From: "Bill Nash (CDI: Public Works)" <bnash@hallcounty.org>
Date: April 11, 2025 at 11:19:22 AM EDT
To: "Kathy Cooper (County Commissioner)" <kcooper@hallcounty.org>
Cc: "William King (CDI: Public Works)" <wking@hallcounty.org>; "Casey Ramsey (Administration)" <cramsey@hallcounty.org>; "Zachary Propes (Administration)" <zpropes@hallcounty.org>
Subject: RE: Friendship rd sewer

From: Kathy Cooper (County Commissioner) <kcooper@hallcounty.org>
Sent: Friday, April 11, 2025 10:50 AM
To: Bill Nash (CDI: Public Works) <bnash@hallcounty.org>
Subject: Friendship rd sewer

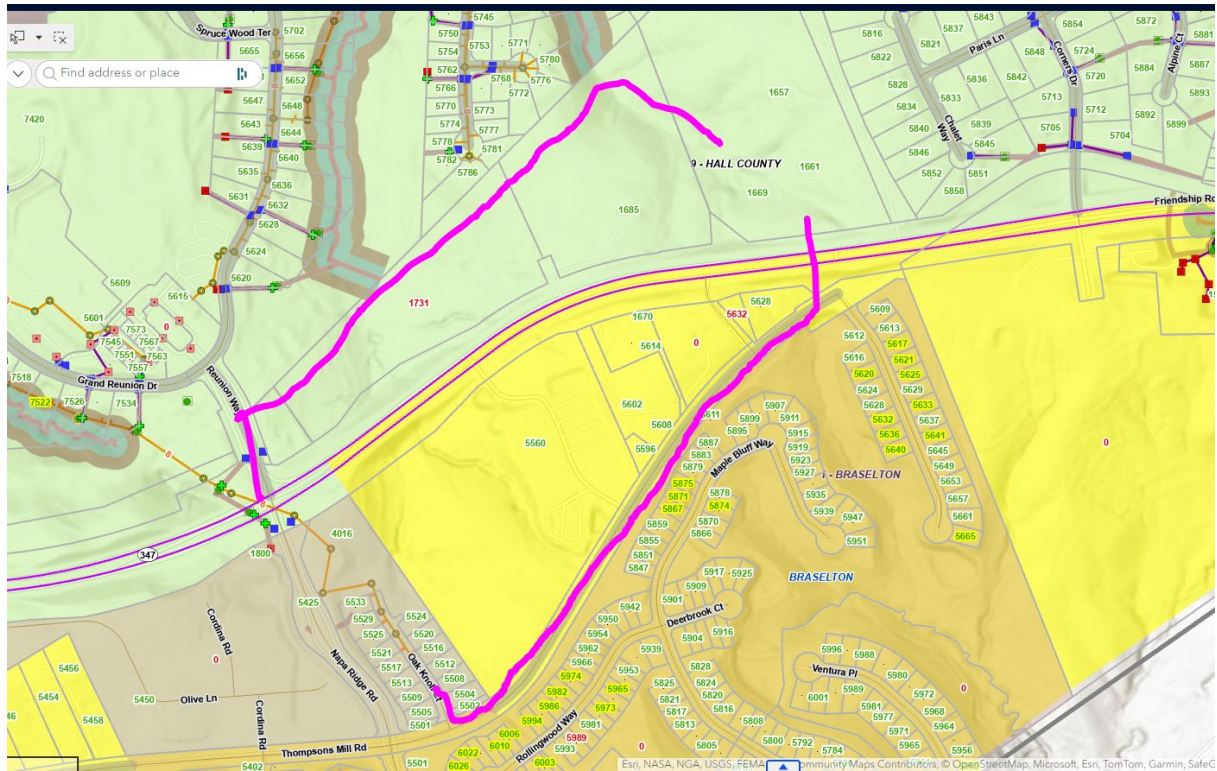
I have confirmed that GDOT will not allow longitudinal encroachment in Friendship Road for a forcemain but would allow a perpendicular crossing.

However, this does not change our recommendation that should be served by Hall County's sewer. I have sketched up two additional options that the developer has not proposed that would connect to our sewer.
